**MONTGOMERY COUNTY HISTORIC PRESERVATION COMMISSION**  
**STAFF REPORT**

<b>Address:</b>	7210 Spruce Avenue, Takoma Park	<b>Meeting Date:</b>	07/25/2018
<b>Resource:</b>	Contributing Resource (Takoma Park Historic District)	<b>Report Date:</b>	07/18/2018
<b>Applicant:</b>	Miki Matsuura	<b>Public Notice:</b>	07/11/2018
<b>Review:</b>	HAWP	<b>Tax Credit:</b>	Partial
<b>Case Number:</b>	37/03-18XX	<b>Staff:</b>	Rebecca Ballo
<b>PROPOSAL:</b>	Lighting installation, new lattice, new electrical box.

Detail: **Figure 2.** Original trellis / lattice on west side to be used as template and replaced. Note that there are vertical and horizontal bars missing due to deterioration rather than design.

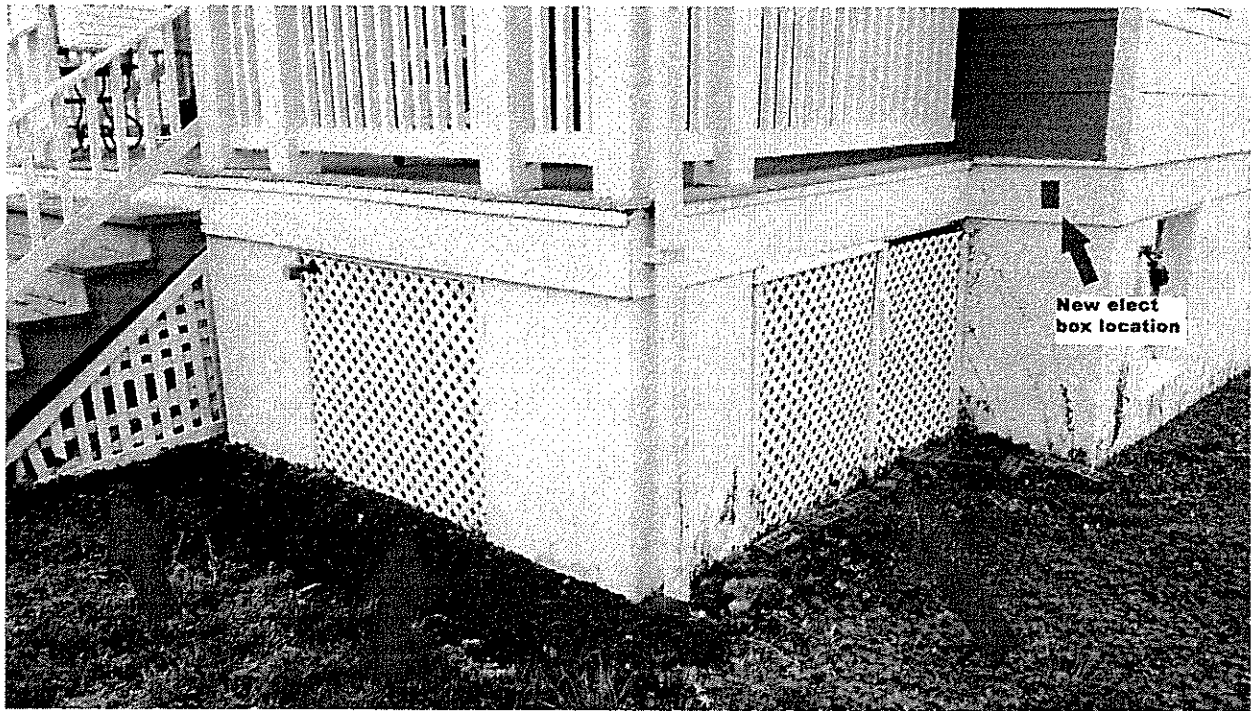
1. Replace trellis / lattice work around front porch on eastern side of house. **See Figure 1.** The current trellis lattice work on the eastern side is of low cost builders grade vinyl trellis with a diagonal pattern and not of original design, materials, or period correct appearance; **See Figure 3.** The western side of the house contains original trellis / lattice work (deteriorating; will be used as a template and replaced) with period correct horizontal and vertical gridding that will be used as a template for fabricating replacement pieces from wood for the eastern side; **See Figure 2.** Replacement of the east side trellis / lattice will restore the home to its original and/or period correct appearance and enhance the value of the home as a historic resource.

Detail: **Figure 3.** East side trellis / lattice to be changed; location of new outdoor electric box.

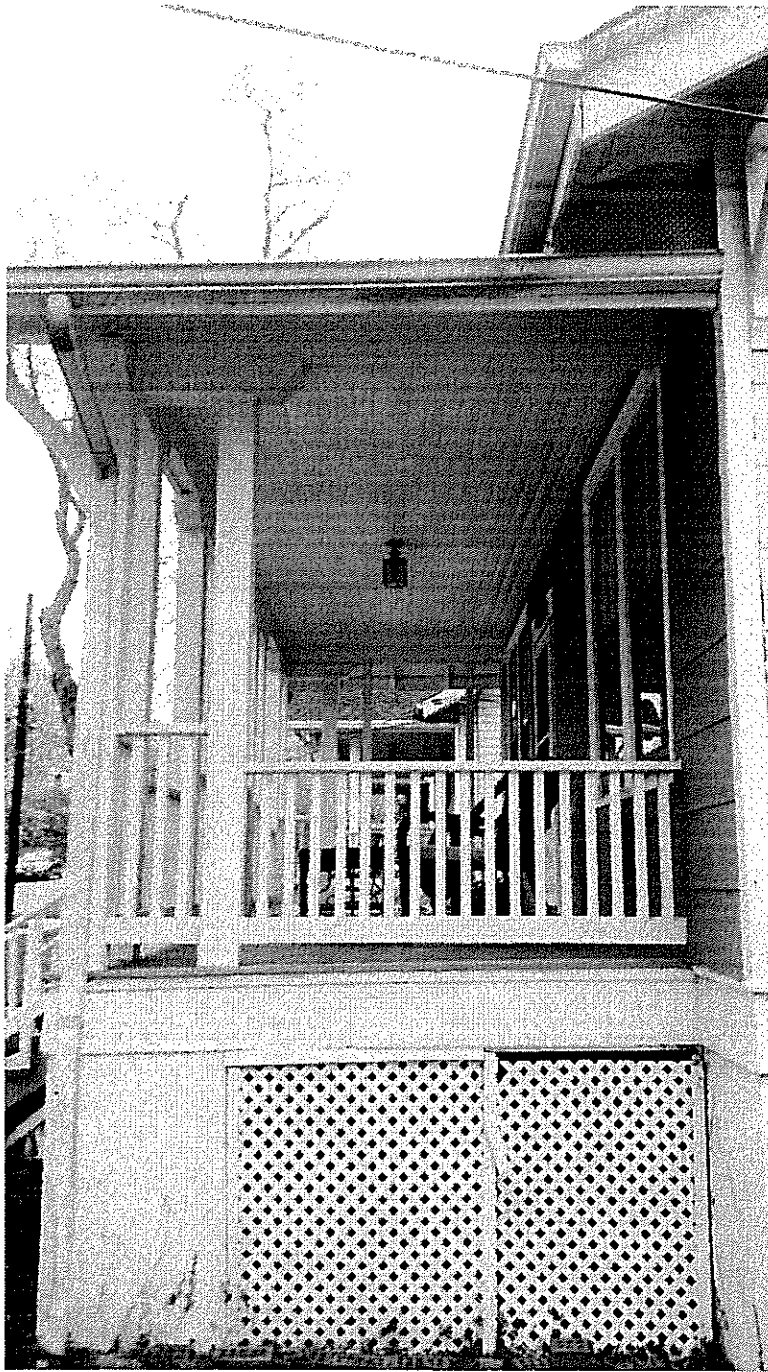
- c. Install a single-gang outdoor electrical outlet to the home front of the home as indicated in **Figure 3** for utility purposes. This outlet will be fitted with an outdoor cover which is colored so as to blend in with the existing paint scheme and is sized so as to be non-obtrusive. A small hole will be drilled in the siding for electrical wiring to pass through. The fixture will be mounted to the trim board with screws. No major structural changes to exterior or significant alteration of the historic features of the house will be involved.
